FEDERAL COMMUNICATIONS COMMISSION

In Re: PETITION FOR RECONSIDERATION
FM Translator K210CL, Lemon Grove, CA
Santa Monica Community College District
BPFT-20020328AAT

In re: K210CL Translator, Lemon Grove, CA

BPFT-20020328AAT Facility ID: 90642

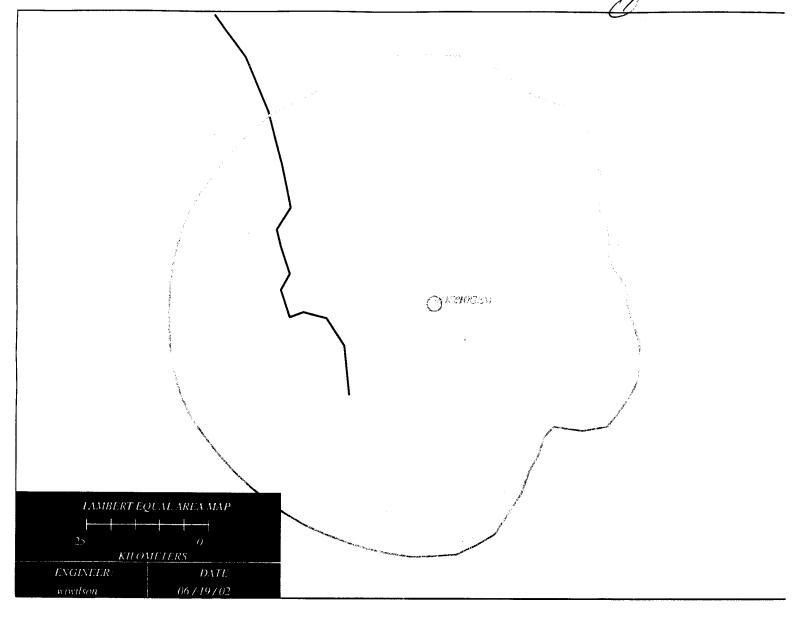
Our engineering study of the application reveals that it is in violation of 47 C.F.R. § 74.1204(a) with respect to the second-adjacent authorized facilities of KPBSFM, San Diego, CA, (License: BLED-19841121LZ and Construction Permit: BPED-19970211IA). Section 74.1204(a) states that an application for an FM translator station will not be accepted if the proposed operation would involve prohibited overlap of predicted field strength contours with any other authorized station. The proposed 100 dBu interference contour overlaps the protected 60 dBu contours of KPBSFM, (see attachments). Applicant recognizes this violation and requests a waiver on the basis that the site is mountainous and unpopulated. To comply with Section 74.1204(d), the applicant must demonstrate that no actual interference will occur to the overlapped station.

In reviewing the submitted study for interference, we find that the terrain roughness study is insufficient for further processing. In cases where irregular terrain causes the predicted contour distances to differ from the distances using the Commission's standard method, Section 73.313(e) of the Commission's rules allows for use of supplemental methods to predict contour distances. Pursuant to Section 73.313(e), "[s]uch supplemental showings should describe the procedure used and should include sample calculations." The applicant must also submit coverage maps containing predicted contour plots using both the standard and supplemental method. The application failed to contain these showings.

We cannot rely on this simple assertion of no potential interference as the basis of grant of the application. The burden of proof lies on the applicant to establish that the supplemental method is valid. Acceptance of supplemental showings involve complicated and extensive engineering reviews by signal propagation experts. In order for us to verify the applicant's contention, the applicant must outline the procedure used to determine the absence of contour

overlap and provide sample calculations of the signal loss claimed. Given the limited data supplied in the application, we can not confirm compliance with the rule section and the showing will not be further considered. Therefore, we find that the exhibits are not sufficient to convincingly show that the proposal would not cause interference to the service area of Station KPBSFM.
